# Work Order ID 101927

Item Name: Crosstube Aft Extended

DRAWING NO. D205-596-107	TITLE CROSSTUBE	REV. B	DART AEROSPACE LTD ENGINEERING ORDER		D.E.O. NO. D205-596-107-B-1	SHEET NO. SHEET 1 OF 1	SCALE NTS
DRAWN <i>AD</i>	CHECKED <i>PH</i>	MFG. APPR. <i>EE</i>	APPROVED <i>MD</i>		DE APPR. <i>#</i>		
DATE 09.05.01	DATE 09.05.15	DATE 09.06.15	DATE 09/06/16		DATE 09/06/16

DRAWING NO. D205-596-107	TITLE CROSSTUBE ASS'Y, HI-HI AFT	REV. B	<b>DART AEROSPACE LTD ENGINEERING ORDER</b>		D.E.O. NO. D205-596-107-B-2	SHEET NO. SHEET 1 OF 1	SCALE NTS
DRAWN <i>q</i>	CHECKED <i>A.P.</i>	MFG. APPR. <i>A</i>	APPROVED <i>md</i>	DE APPR. <i>md</i>			
DATE 13.11.11	DATE 13.11.14	DATE 13.11.19	DATE 13/11/21	DATE 13/11/21

**FIGURE 1 - SUPPORT INSTALLATION**

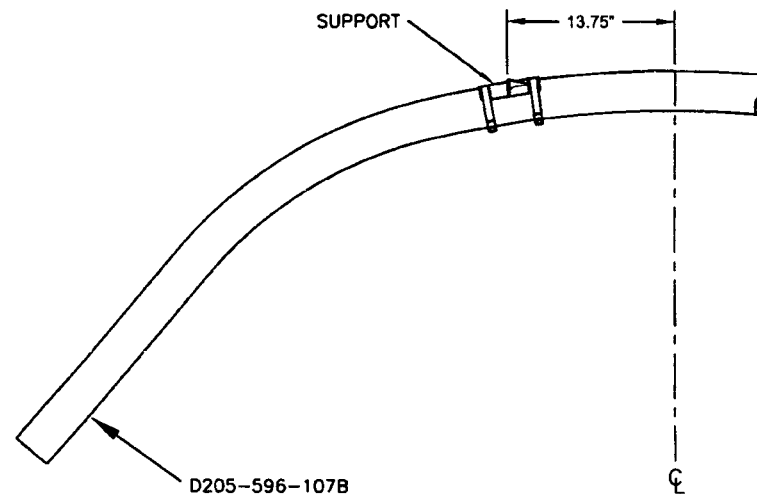
ADD THE FOLLOWING CROSSTUBE ASSEMBLY:

Part Number	Description
D205-596-107B	CROSSTUBE ASSEMBLY (214 HI-HI AFT)

THE D205-596-107B CROSSTUBE HAS THE SAME PARTS LIST AS THE D205-596-107 CROSSTUBE. HOWEVER, INSTALL THE SUPPORTS AS SHOWN IN FIGURE 1 OF THIS ENGINEERING ORDER. THE NEW KIT IS OTHERWISE ASSEMBLED PER THE D205-596-107 CROSSTUBE.

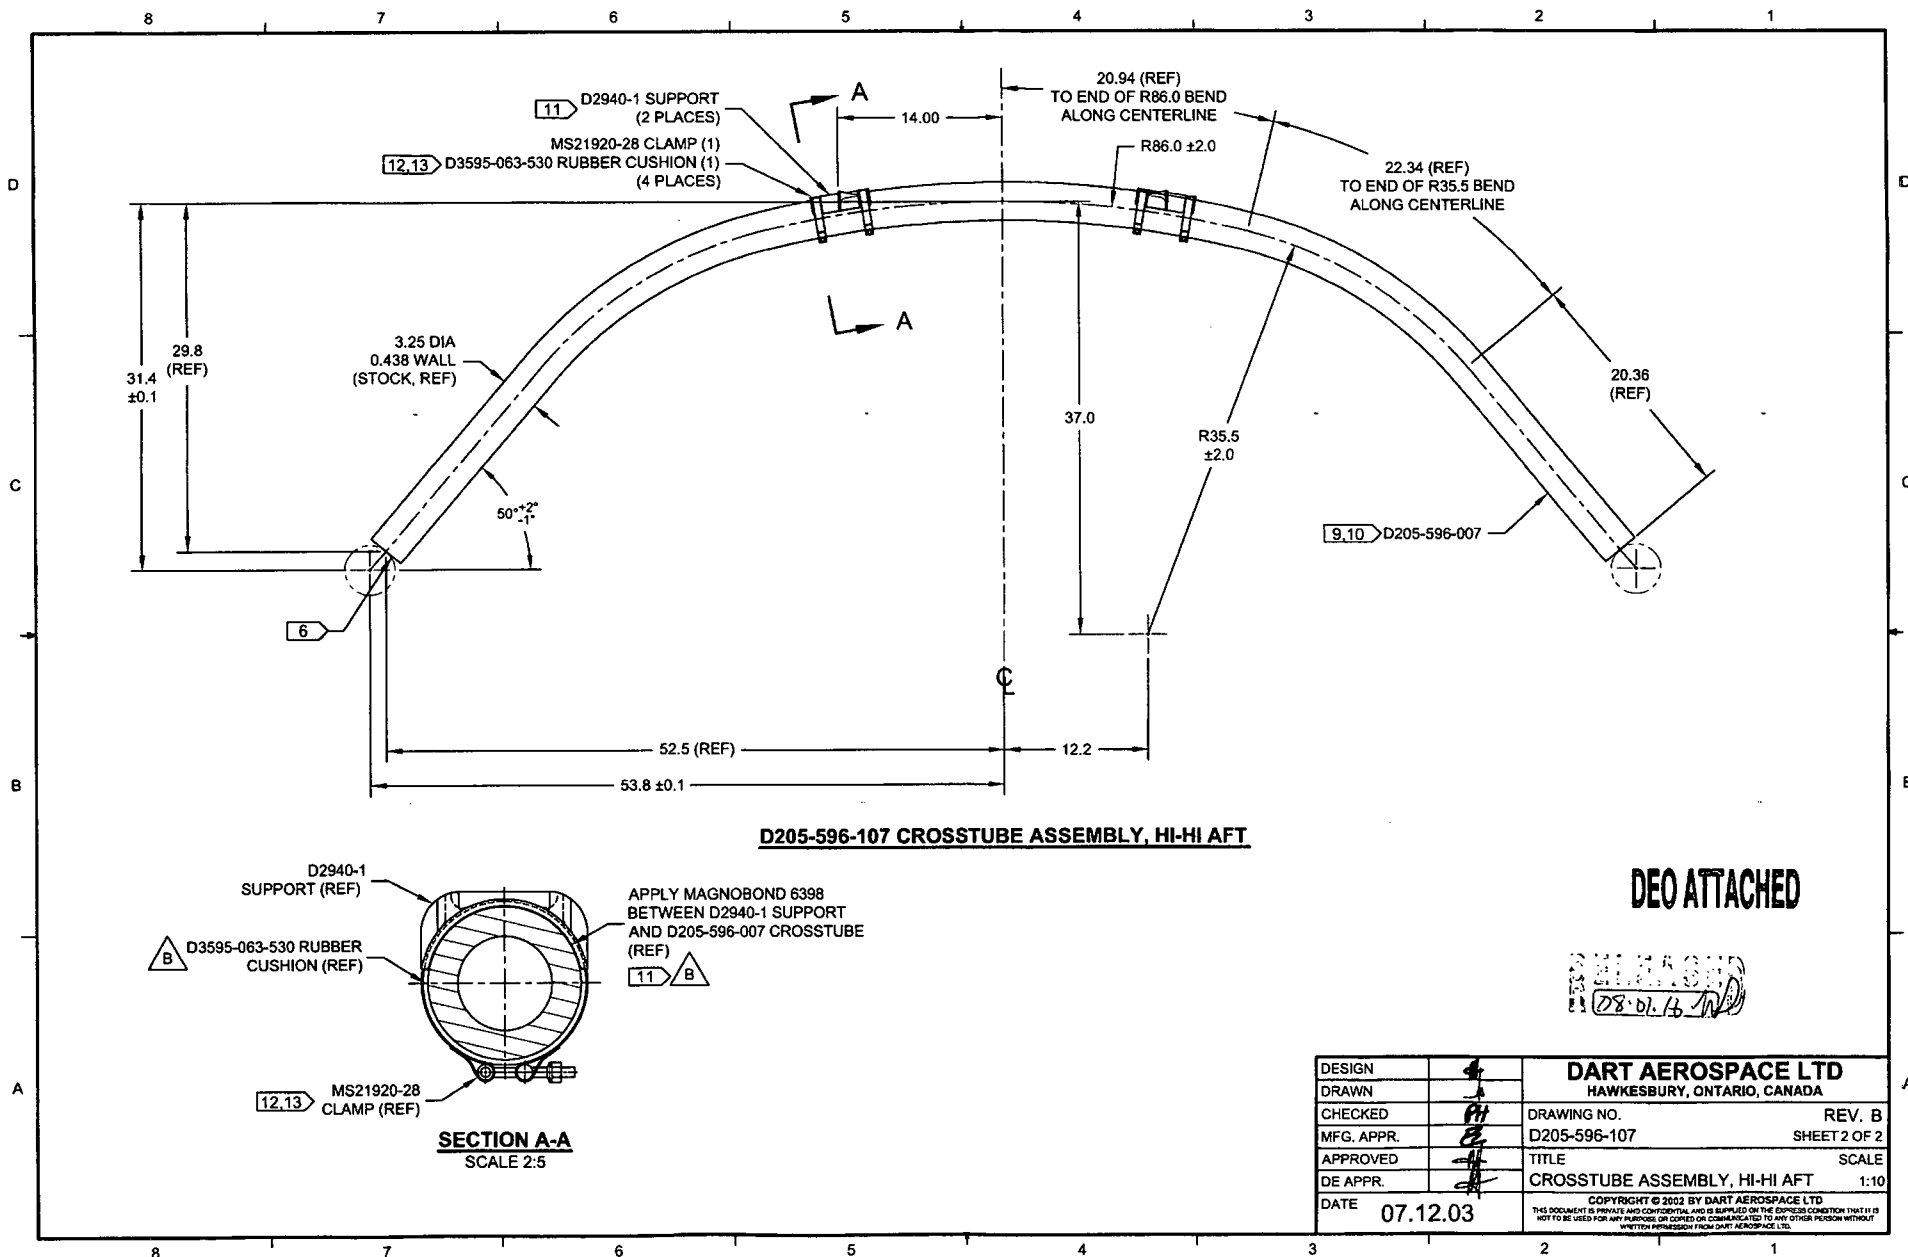
REPLACE MAGNOBOND WITH PROSEAL.

NOTE 11 & 13, SHEET 1 IS AMENDED AS FOLLOWS:

- 11) APPLY A 0.03" TO 0.06" THICK LAYER OF MAGNOBOND 6398 TO THE SURFACE OF D2940-1 THAT WILL BE IN CONTACT WITH THE CROSSTUBE. LET CURE FOR 12 HOURS AFTER INSTALLATION AND PRIOR TO PACKAGING.
- 13) TORQUE CLAMPS 80 TO 100 IN-LB.

- 11) TO INSTALL D2940-1 SUPPORT: ABRASE MATING SURFACE OF SUPPORT AND CROSSTUBE WITH 180-GRIT SANDPAPER AND REMOVE RESIDUE WITH MEK (OR EQUIVALENT). APPLY A 0.04" TO 0.07" THICK LAYER OF PROSEAL 890 CLASS B-2 (OR AMS-S-8802 CLASS B-2) SEALANT TO MATING SURFACE OF SUPPORT.
- 13) TORQUE CLAMPS 80 TO 100 IN-LB. ENSURE AT LEAST 1.5 THREADS SHOWING IN SAFETY AND THAT NUT HAS NOT BOTTOMED-OUT AFTER TORQUING. PRIOR TO PACKAGING, RE-CHECK TORQUE ON CLAMPS AFTER PROSEAL 890 SEALANT HAS CURED FOR 72 HOURS.

**FIGURE 1 - SUPPORT INSTALLATION**

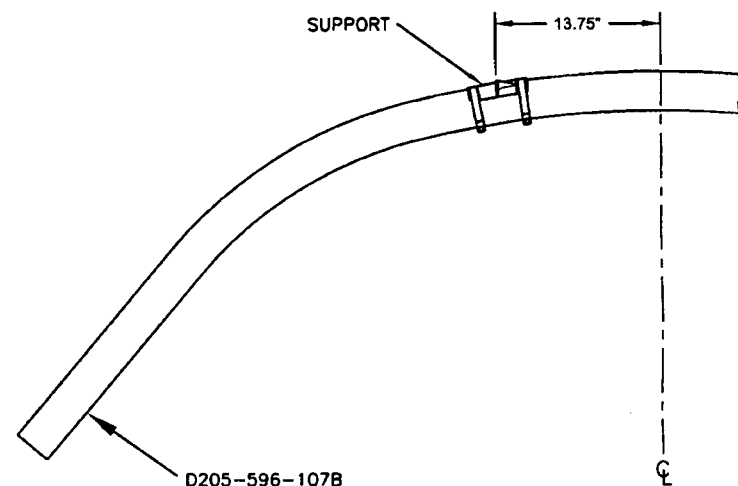
ADD THE FOLLOWING CROSSTUBE ASSEMBLY:

Part Number	Description
D205-596-107B	CROSSTUBE ASSEMBLY (214 HI-HI AFT)

THE D205-596-107B CROSSTUBE HAS THE SAME PARTS LIST AS THE D205-596-107 CROSSTUBE. HOWEVER, INSTALL THE SUPPORTS AS SHOWN IN FIGURE 1 OF THIS ENGINEERING ORDER. THE NEW KIT IS OTHERWISE ASSEMBLED PER THE D205-596-107 CROSSTUBE.
